**Staff Report: Limited Site Plan Amendment 81995030F, Hoyle's Mill Village,
Section II**

DESCRIPTION: Addition of 18 parking spaces and associated changes to a play area, landscaping, and sidewalk resulting in 2,790 square feet of additional impervious surface, which requires a waiver of the 21.114% impervious limit. Site located within the 155.90-acre tract area of Section 2 of the Hoyle's Mill subdivision in the R-200 zone on Kimono Circle, approximately 270 feet east of Polynesian Lane within the Germantown Master Plan Area.

RECOMMENDATION: Denial

SUBJECT: Site Plan Amendment 81995030F
Waiver of Impervious Surface
Hoyle's Mill Village, Section II

**MODIFIED
OPEN SECTION TERTIARY ROAD
(OUTSIDE SUBURBAN DISTRICT)
(MCDOT STD. NO. 210.02)**

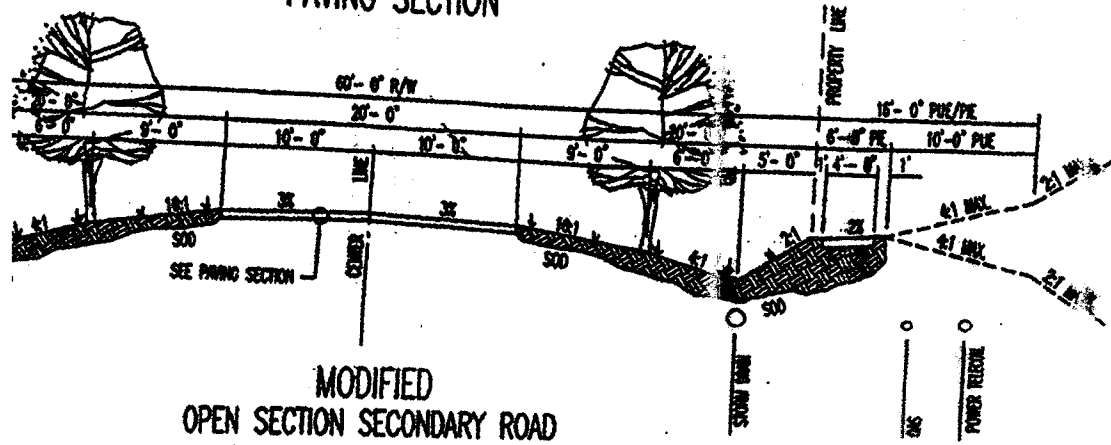
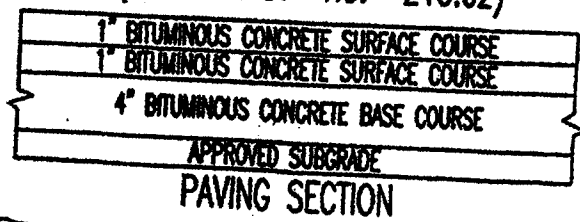
was designed as an open section tertiary road, with only 20' of paving, and was never designed for parking of all the vehicles which are forced to park there on a regular basis. Enclosed is a copy of the approved paving section for tertiary roads in Hoyles Mill Village, showing the narrow width of Polynesian Lane. This has caused a hazard, making it difficult for fire trucks, school buses, or trash and recycling trucks to pass through.
